SECTION 504 COMPLIANCE REVIEW REPORT

Denver Museum of Nature and Science

Office of Diversity and Equal Opportunity

March 2011

Figure 1-- Slanted Wall Entry to Space Odyssey Exhibit

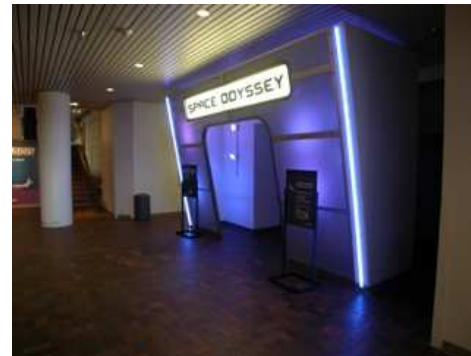
- a. The slanted walls adjacent to the exhibit entrance off the main circulations core do not provide at least 80" head height. See Figure 1
- b. There are no cane detectable barriers below the suspended TV's, the slanted wall mounted "space walking" plaque and cylindrical display below these TV's just left of the "Astrotot Training" area (UFAS 4.4).

Figure 13 - Inaccessible Route to Stage

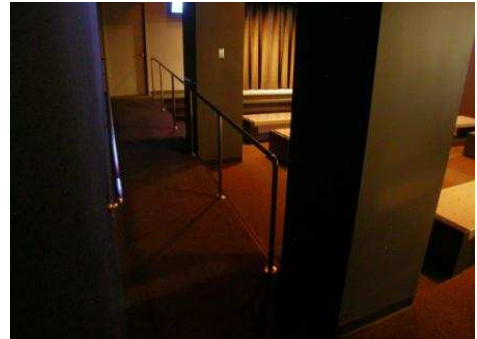
on the left side of the stage to the performing portion of the stage is (at only 22") not at least 32" wide at the support post of the ramp handrail. (UFAS 4.3.3). There is inadequate level maneuvering space for the push side of this stage door (UFAS 4.13.6). See Figure 13

Figure 24 - Protruding Trim at South Atrium

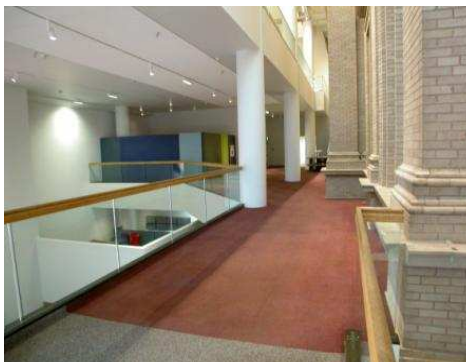
visitors and UFAS 4.1.2(18) requires 8 wheelchair spaces be provided for the auditorium. The handrail in front of the wheelchair seating areas is so high (32") that it blocks sight lines from these wheelchair areas as compared with other visitors in the theater (UFAS 4.33.3) and the upper handrail should be removed or lowered to provide unobstructed lines of sight comparable to those offered to others without disabilities.

Figure 38 - Inaccessible Landing at the Automatic Doors of the Special Events Entrance (Steep 5.7% Cross Slope)

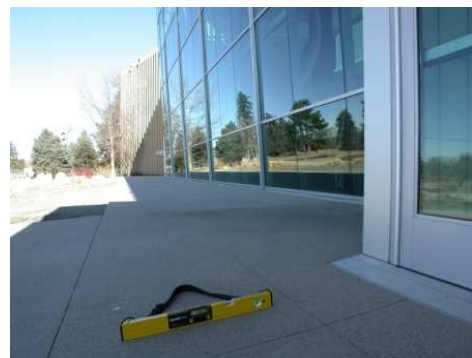
- a. The cross slope of a portion of this approach walk exceeds (at 3.5%-4.4%) the maximum allowable 2% (UFAS 4.3.7). That portion runs between the existing park bench/statuary and the L-shaped narrow approach walk installed as an alternative accessible route to using the steep (8.0 %) main approach ramp in front of the entry doors. See Figure 37

Figure 42 - Sprinkler Stand Pipes Protrude into Garage Approach Routes

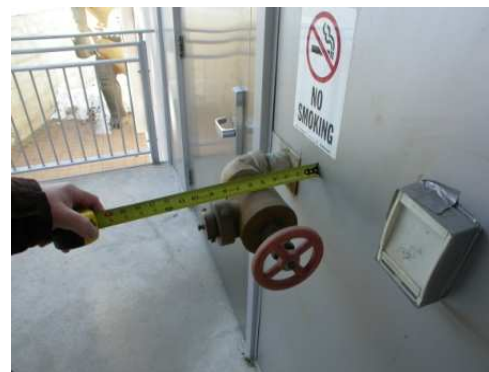
2. The valve for the fire sprinkler standpipe system on the wall between the door to the fire stairs and the elevators on each of the levels of the parking deck projects further than 4" into the circulation route above 27" (UFAS 4.4). See Figure 42

Figure 44 - Low Head Height at "Elevator/Stair" Sign in Parking Garage

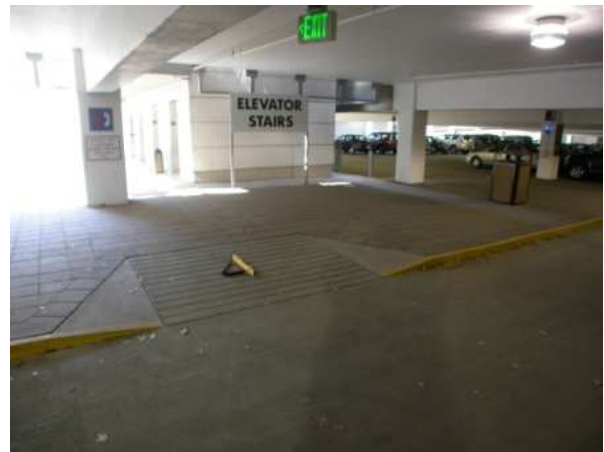
6. The large "Elevator Stairs" sign at the east end of the elevator tower on both Levels L2 & L3 is on the approach circulation route to the elevators and lacks the minimum required 80" head height per UFAS 4.4. See Figure 44
